## Specification Change Notice

Brushless Motors and Driver Packages **BMU** Series

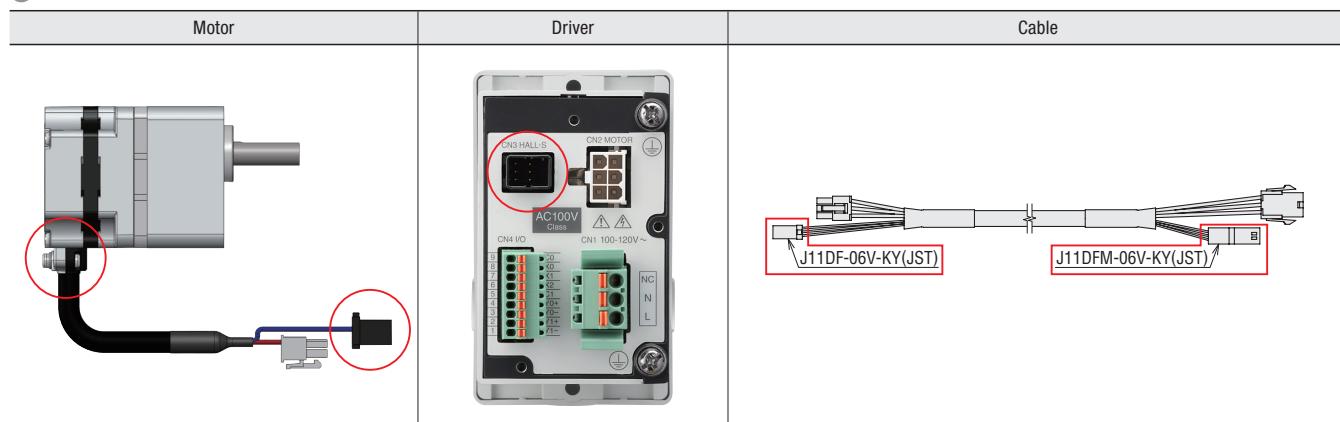
- 1) Sensor connector changes (motor, driver, cable)
  - 2) Shape changes of the cable clamps (motor, IP65 type only)
  - 3) Degree of protection IP20 → IP40 (motor, standard type only)
  - 4) Parameter setting changes (driver)
    - ① Front panel switch operation is disabled (for operations using external signals)
    - ② Initial lower limit value for speed setting range
    - ③ Indication on the panel while the lock function is enabled
    - ④ Indication on the panel while the alarm is activated
- For details on the changes, see the next page.
